FED. ROAD DIST. NO.	DIVISION	PROJECT NO.	SHEET NO.	TOTAL SHEETS
9	COLO.	125-3(35)258	53

COLORADO
 DEPARTMENT OF HIGHWAYS
 3 SPANS @ 28'-0" B.W.D., 3 SPANS @ 30' No. B.W.D.
 CONCRETE SLAB & GIRDERS, 38 Rows. 2 Cures
 GENERAL LAYOUT, SUMMARY of QUANTITIES and GENERAL NOTES
 Across County Road
 Sta. 2753+00
 Near KELVIN Sec. 34 T. 6N R. 68W
 Designed by *A. D. Newcomb*
 Made by *A. J. P.*
 Checked by *A. J. P.*
 Approved by *A. D. Newcomb*
 Bridge Engineer
 Date: Sept. 16, 1963

C-17-ES No. BOUND
 STRUCTURE NO. C-17-EI So. BOUND

SUMMARY OF QUANTITIES

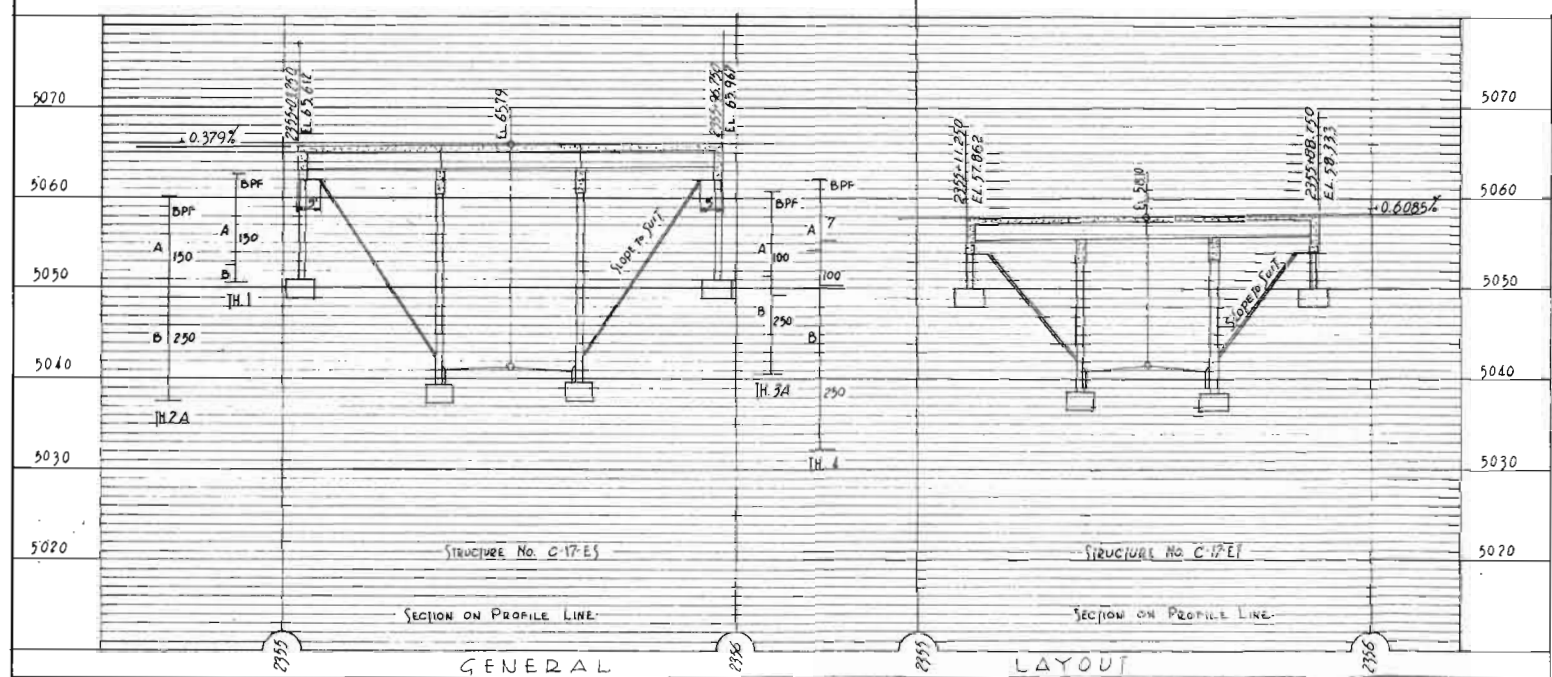
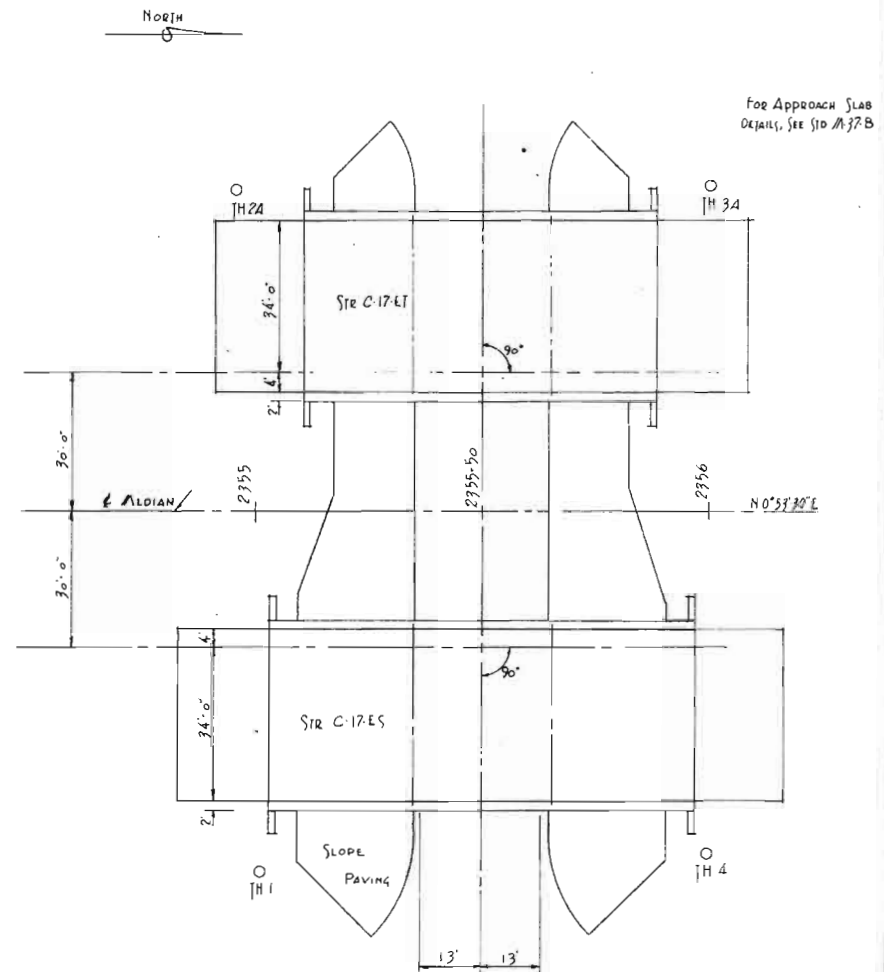
Revised: Changed Span No 2 C-17-ET from 22'-0" to 30'-0"; Plan, Profile & Quantities -- 3-19-64 RRA.

BENDING DIAGRAMS & BAR LIST

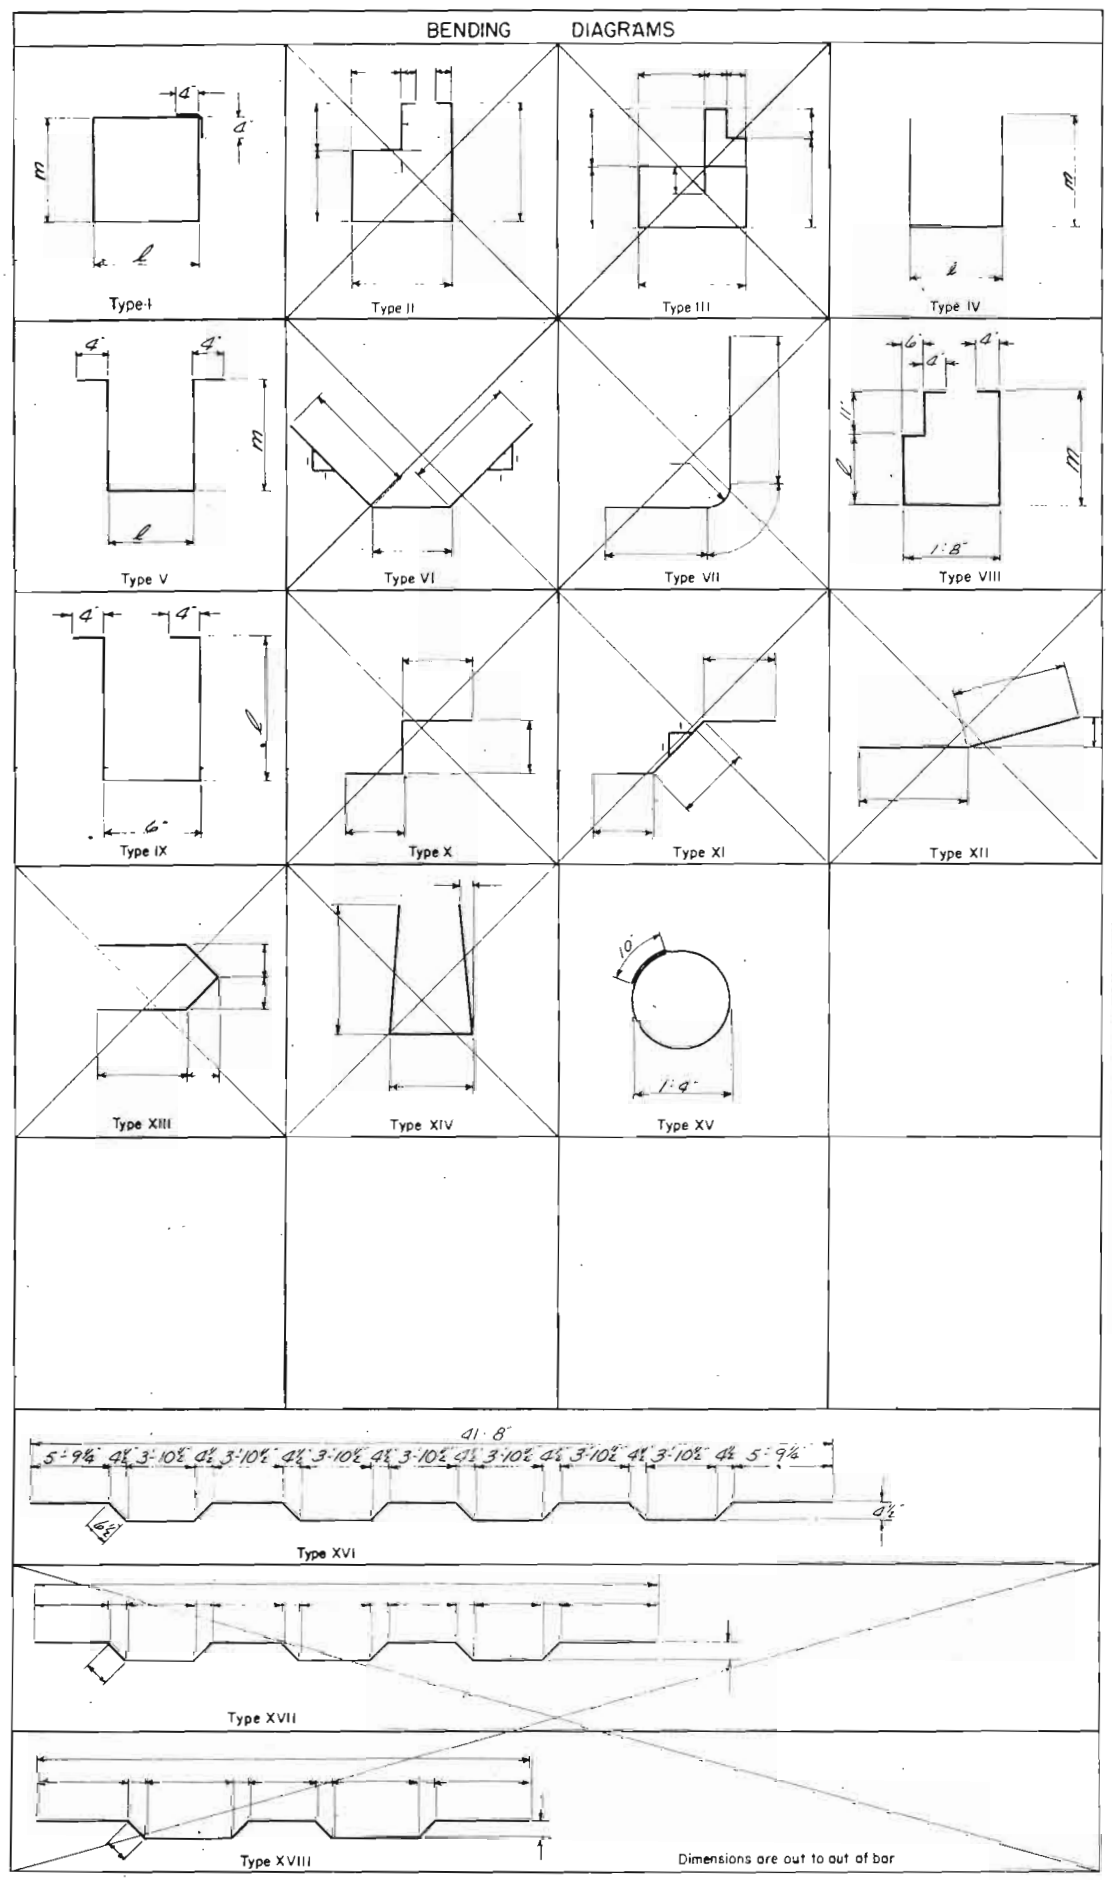
Revised: Superstructure & Pier Bar Lists for Str C-17-ET - March 19, 1964 R.R.A.
Revision: Corrected Structure N° & Pier #2 Bar List - March 31, 1964 R.R.A.

COLORADO
 DEPARTMENT OF HIGHWAYS
 DETAILS OF SUPERSTRUCTURE

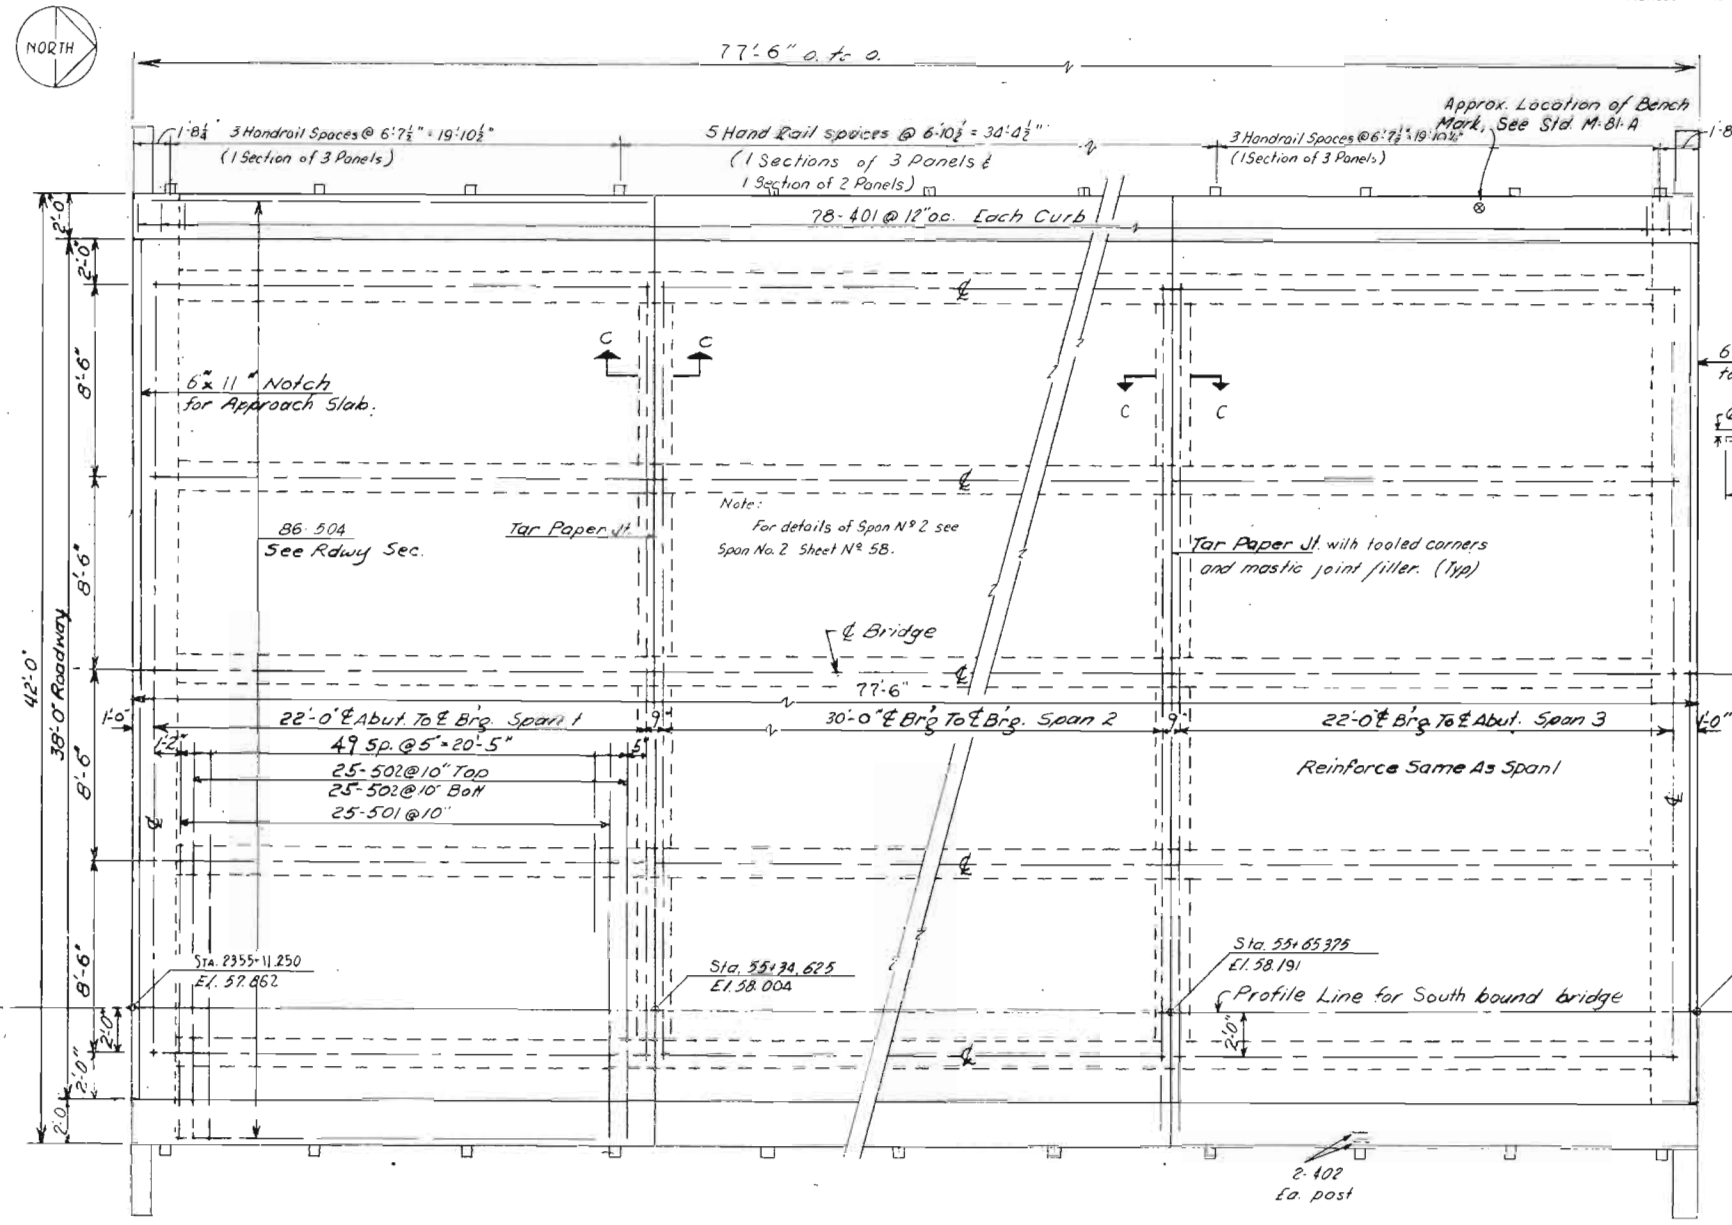
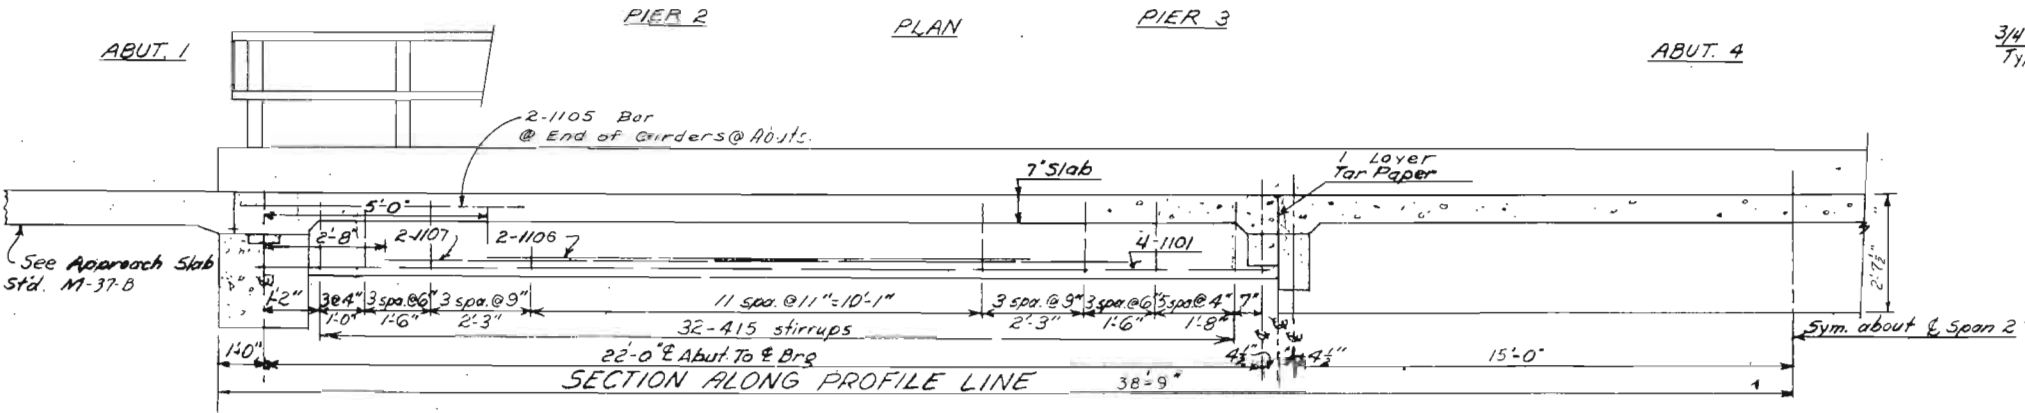
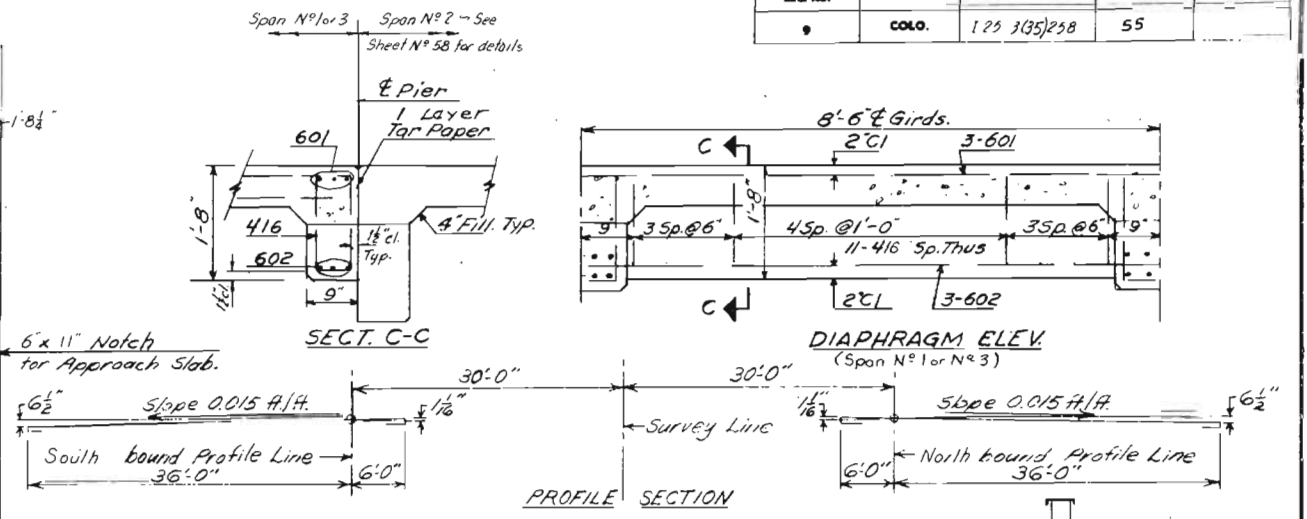
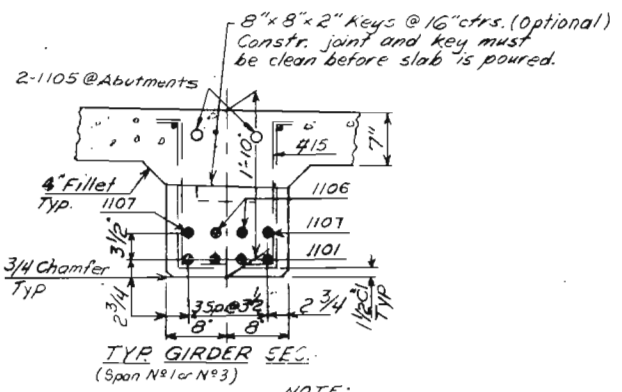
Revised: Changed Span No. 2 from 22'-0" to 30'-0" - MARCH 19, 1968 R.R.A.

PIER 2 AND 3

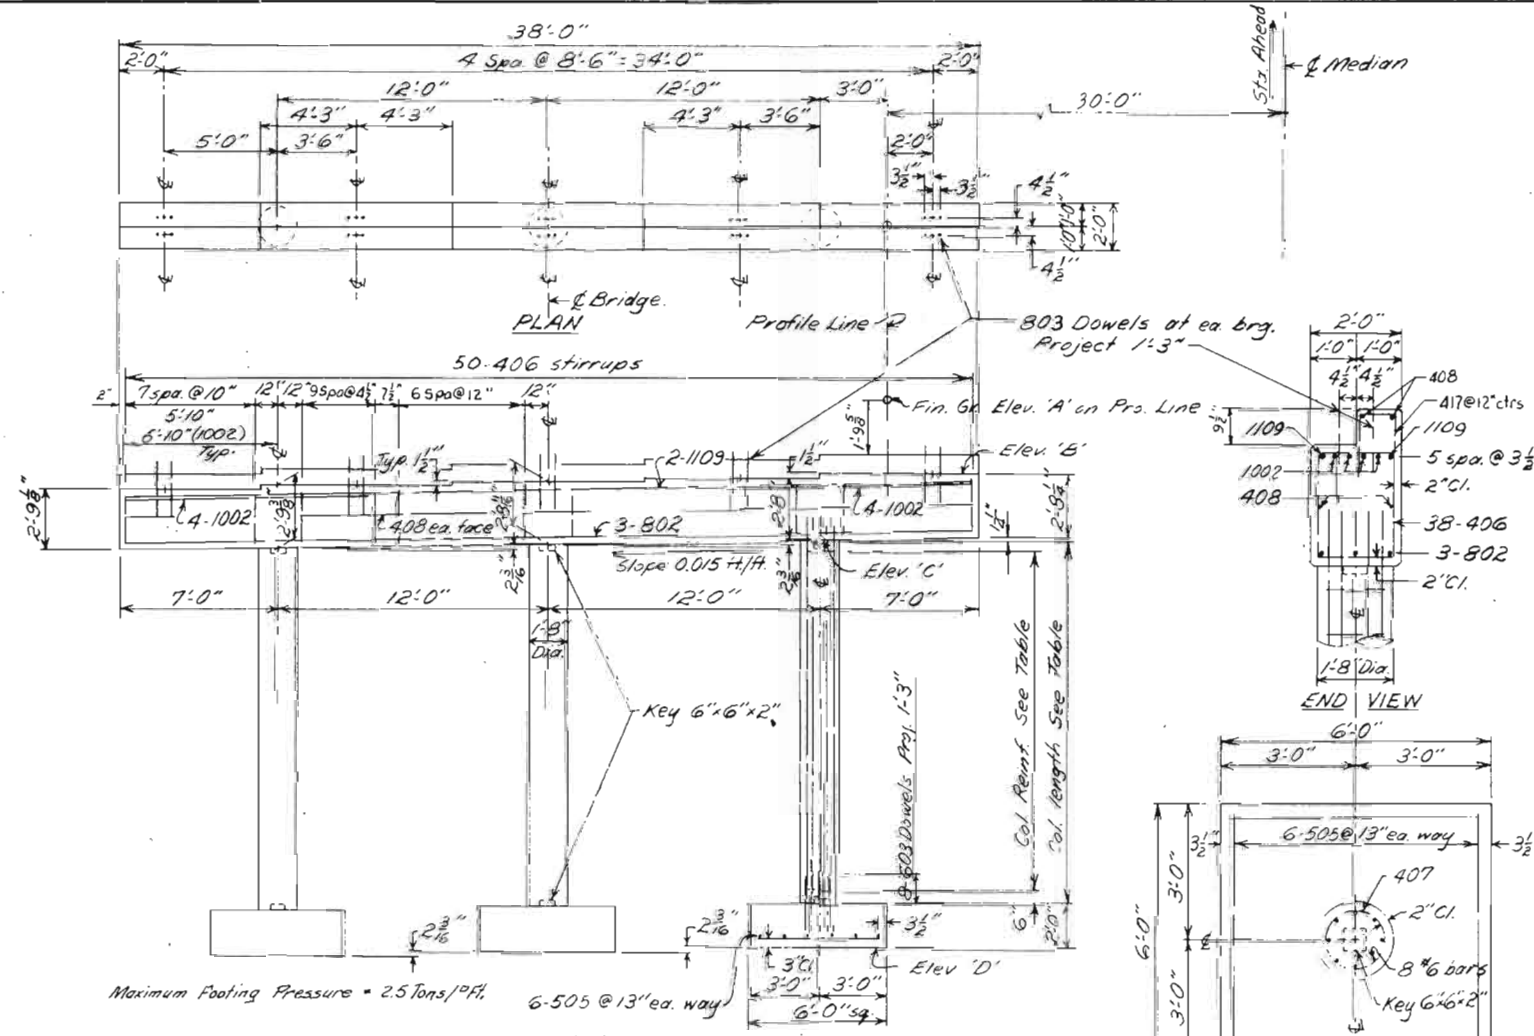
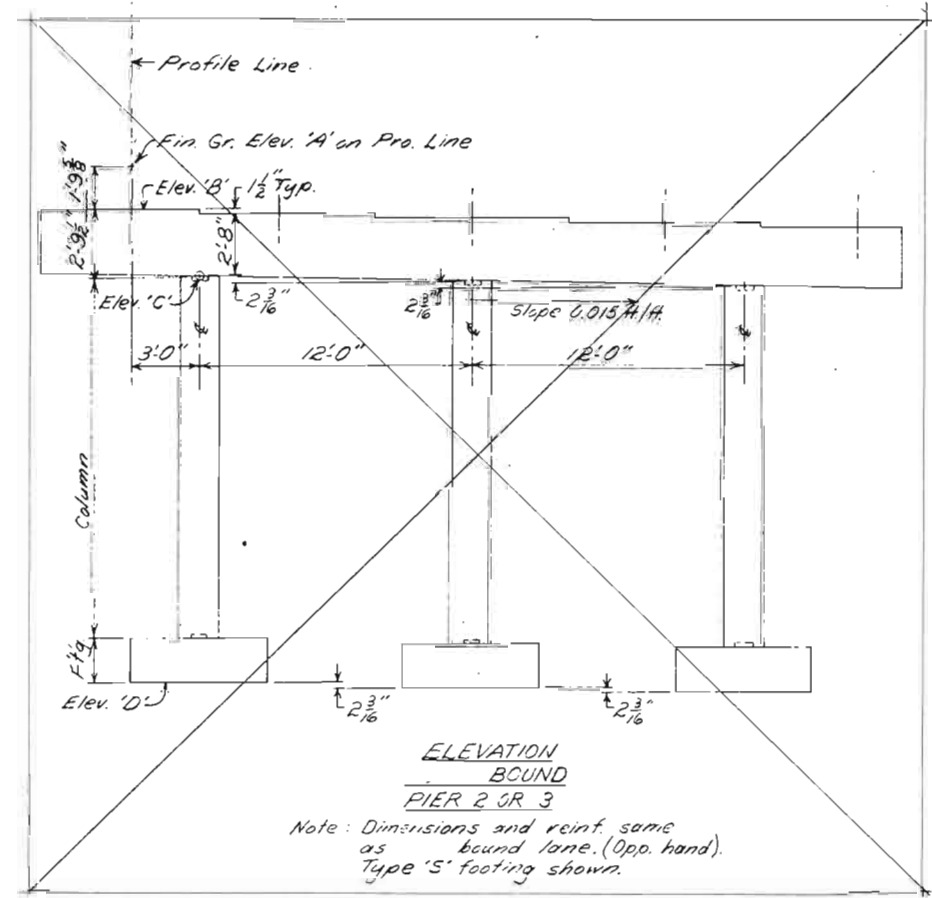
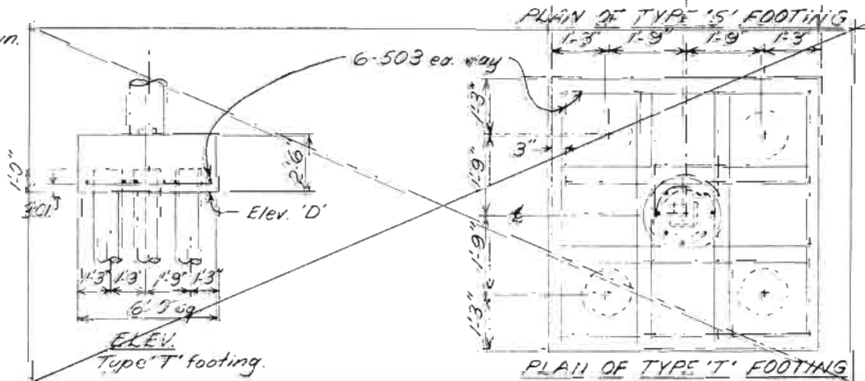
Revised: Stations, Elevs. & Added 9 1/2" Step - March 13, 1964 RRA
